Wichita-Sedgwick County Metropolitan Area Planning Department

August 6, 2007

Re: BZA2007-35: Zoning Adjustment to reduce the parking requirement from 17 to 13 parking spaces on property zoned "GC" General Commercial, generally located east of Washington and north of Gilbert (732 S. Washington Ave).

D Site Layout
1"=100'

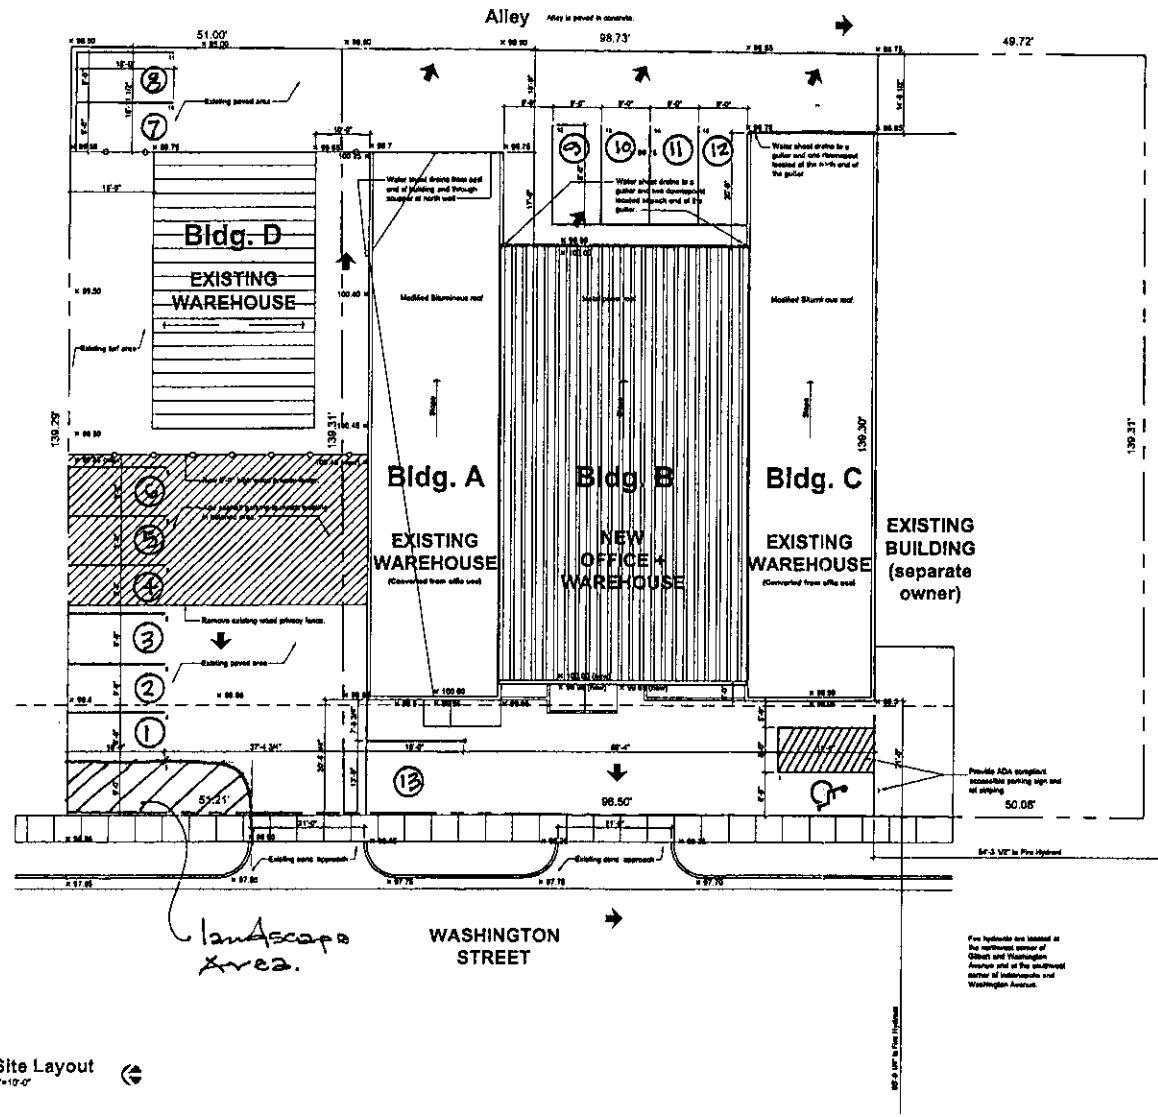
We have reviewed your Zoning Adjustment request to reduce the parking requirement on the above-referenced property. From reviewing your application we understand that you plan to reconfigure your existing parking due to additional landscaping required for your site in conformance to the landscape requirements. Since the use at this site is for warehousing, the maximum amount that the parking requirement can be reduced is by 25%. Your plan indicates 13 parking spaces, a 23% reduction of the 17 spaces as allowed by the Unified Zoning Code (UZC).

Our signatures below indicate that an administrative adjustment to reduce parking by 4 spaces, from 17 to 13 is hereby granted for the aforementioned property subject to the following conditions:

- 1) The site shall be developed in general conformance with the approved site plan.
- 2) The parking area shall be paved and marked.
- 3) Any violation of these conditions shall render the Administrative Adjustment null and void.
